Access Compliance Report

Public Rights-of-Way

Intersection ID: 3612	Main Street: BRIDLE_RIDGE_LN	Cross Street: FURLONG_TL	Location: SE
ADA ID: 72421821D586	Ramp Type: Perp	Initial Pass/Fail: Fail	Overall Compliance: No
		Severity Score: 10

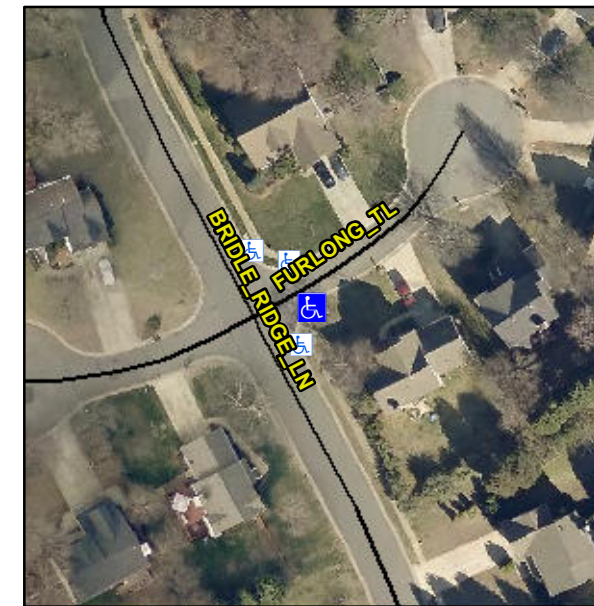
Not Found, R304.5.1, R304.5.3

Compliance	Description	Data	Compliance	Description	Data
N/A	Ramp Length (in)	53.0	Yes	Ramp Slope (%)	7.3
No	Ramp Width (in)	47.0	No	Ramp XSlope (%)	2.1
N/A	Flare Type LT	N/A	N/A	Flare Type RT	N/A
N/A	Flare Slope LT (%)	N/A	N/A	Flare Slope RT (%)	N/A
N/A	Flare Traversable LT?	N/A	N/A	Flare Traversable RT?	N/A
N/A	Landing Length (in)	N/A	N/A	DWS Provided?	N/A
N/A	Landing Width (in)	N/A	N/A	DWS Contrast?	N/A
N/A	Landing Slope (%)	N/A	N/A	DWS Length (in)	N/A
N/A	Landing X Slope (%)	N/A	N/A	DWS Full Width?	N/A
N/A	Landing Curb? (Y/N)	N/A	N/A	DWS Offset (in)	N/A
N/A	Shared Landing?	N/A			
N/A	Gutter Ponding?	N/A	N/A	Gutter Slope (%)	N/A
N/A	Gutter Lip Ht (in)	N/A	N/A	Gutter X Slope (%)	N/A
N/A	Painted X Walk1?	No	N/A	Painted X Walk2?	N/A
	X Walk 1 Direction	To N		X Walk 2 Direction	N/A
N/A	X Walk 1 Width (in)	N/A	N/A	X Walk 2 Width (in)	N/A
	X Walk 1 Slope (%)	2.3		X Walk 2 Slope (%)	N/A
	X Walk 1 X Slope (%)	0.8		X Walk 2 X Slope (%)	N/A

Remove & Replace Entire Ramp.
